April 24, 2008

The ORD Class B Users Group has concluded their meetings and requests that the FAA considers their options for changing the airspace to accommodate the ORD traffic landing on the East and West runways that have been vectored outside the ORD Class B.

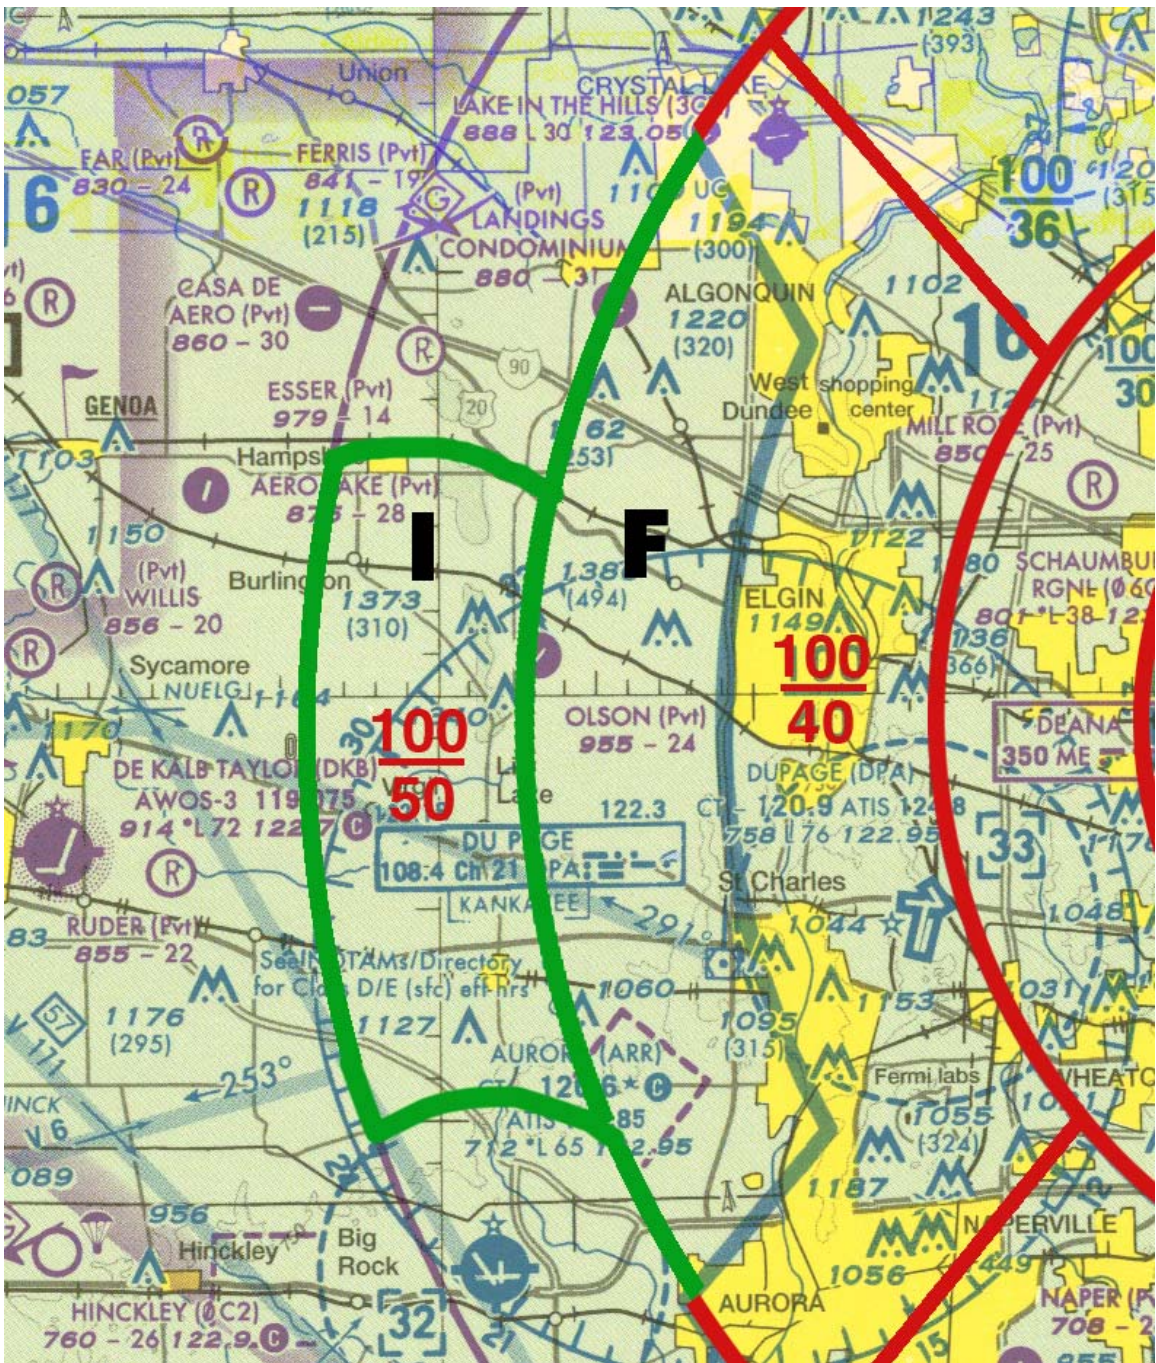
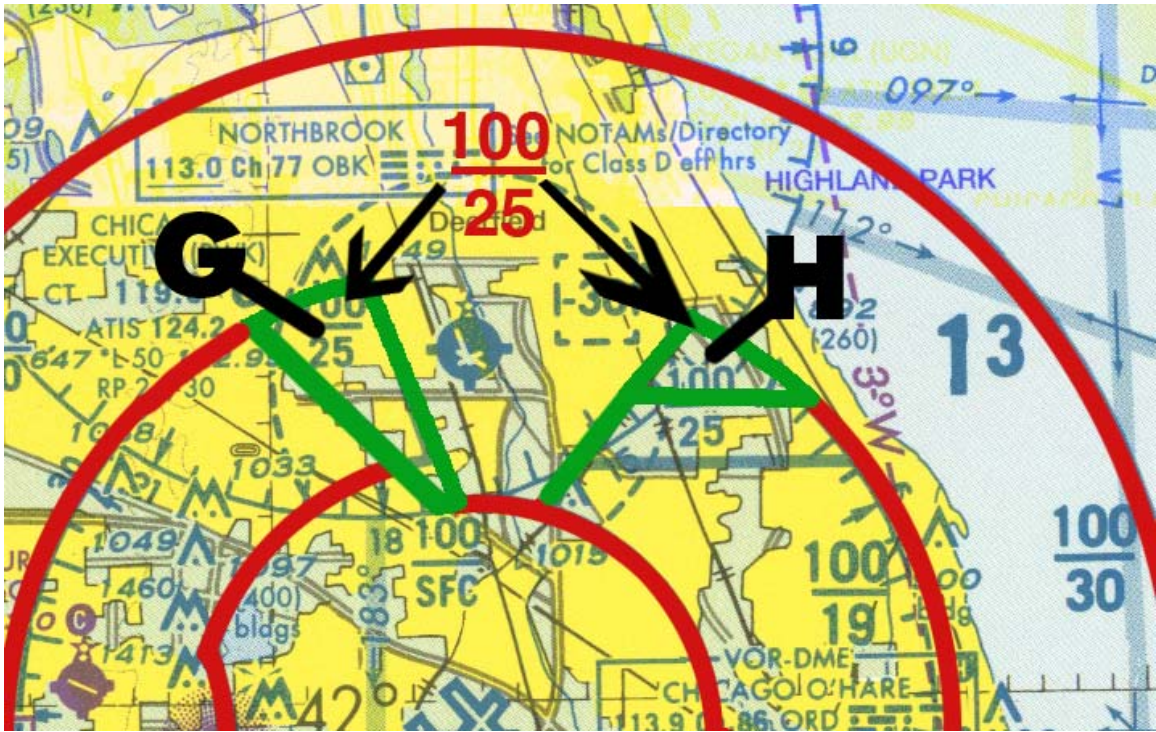
## **Area I – West Class B Extension**

The area bordered on the East by the 25NM ORD DME ring and the West by the 30NM ORD DME ring and on the North by the railroad tracks and the south by the Class D airspace of the KARR airport. The base altitude of this sector will be 5000’ and the top at 10,000’.

Originally the FAA requested a base altitude of 4000’ so they can do triple approaches at 4, 5, and 6 thousand feet. With the glide slope intercept altitude for the east runways at approximately 9800’ at the 30NM ring we feel that 5, 6 and 7 thousand

feet for arrivals are appropriate. The airline representatives that attended our meetings agreed with this assumption. If there becomes a need for an aircraft to be a 4000' for the approach, this aircraft can be kept inside the 25NM ring.

The area between 15 and 25NM ORD DME (**Area F**) already bordered on the North and South by the original Class B will have a base of 4000' and a top of 10,000'.

### **Area E – East Class B Extension**

The area bordered on the East by the 30NM ORD DME ring and the West by the 25NM ORD DME ring and on the North by 070° ORD Radial and the south by the 110° ORD Radial. The base altitude of this sector will be 5000' and the top at 10,000'.

Originally the FAA requested a base altitude of 4000' so they can do triple approaches at 4, 5, and 6 thousand feet. With the glide slope intercept altitude for the west runways at approximately 9800' at the 30NM ring, again, we feel that 5, 6 and 7 thousand feet for arrivals are appropriate. The airline representatives that attended our meetings agreed with this assumption. If there becomes a need for an aircraft to be a 4000' for the approach, this aircraft can be kept inside the 25NM ring.

There was originally no mention of a need to protect the airspace outside 25NM for Runway 22L arrivals. In fact the question was brought up about this requirement and we were told that there was no need and there was never any data produced to show that there was, in fact, a need. In addition, since Runway 22L is a single runway used for arrivals, and the predominate use of the airport will be the 27's and 28's; we feel there is no need to have additional airspace to protect the area outside the 25NM ring.

### **Area G – 2500' Area West of KPWK**

Existing area extend from the 6NM ORD DME ring to the 5NM ORD DME ring to accommodate the ILS 16 circle to runway 34 at KPWK without entering the ORD Class B Airspace.

### **Area H – 2500' Area East of KPWK**

The area bordered on the East by the 10NM ORD DME ring and the West by the railroad tracks that intersect the 10NM ORD DME ring and the south by Palatine/Willow Rd. The base altitude of this sector will be 2500' and the top at 10,000'. This area is the northern most section of the original airspace that was used for the Glenview Naval Air Station.
